Valley Mill Halse
1600 E. Randolph Rd.
Silver Spring

HAWP 33/7-08A

SUBJECT: Historic Area Work Permit #473951 - Swale installation

EXPEDITED
MONTGOMERY COUNTY HISTORIC PRESERVATION COMMISSION
STAFF REPORT

PLAN

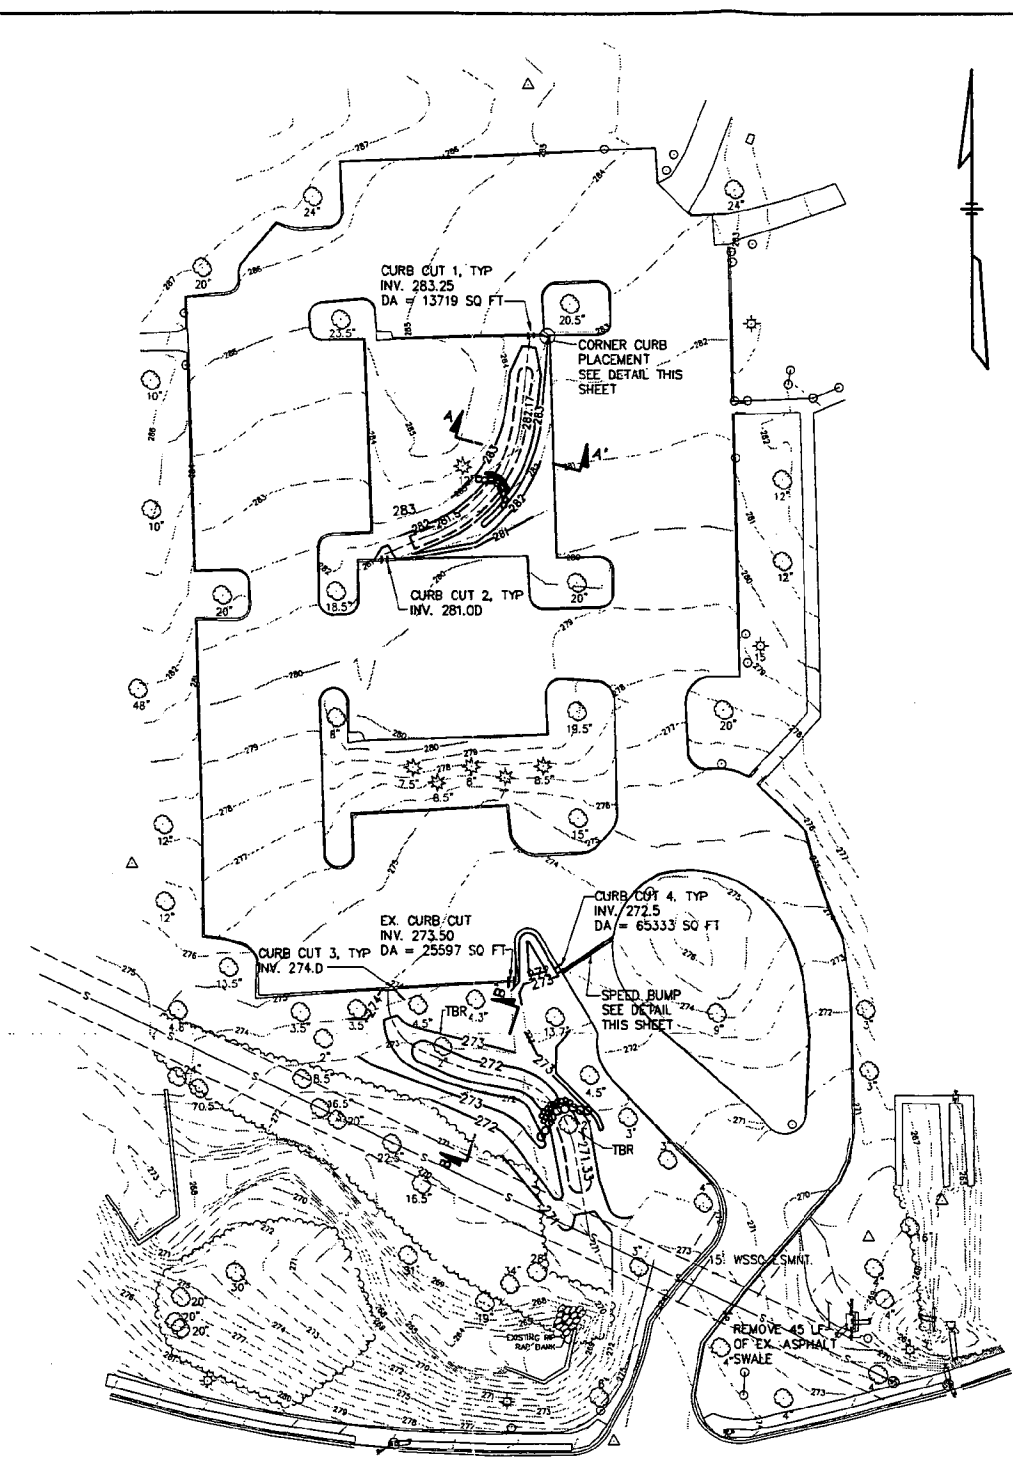
W.Q. IMPROVEMENTS LOD
5 NOMLO STAY WITHIN
10FT OF TRAV. PT. 10Z
IN THE DIRECTION OF THE
MILL RACE.
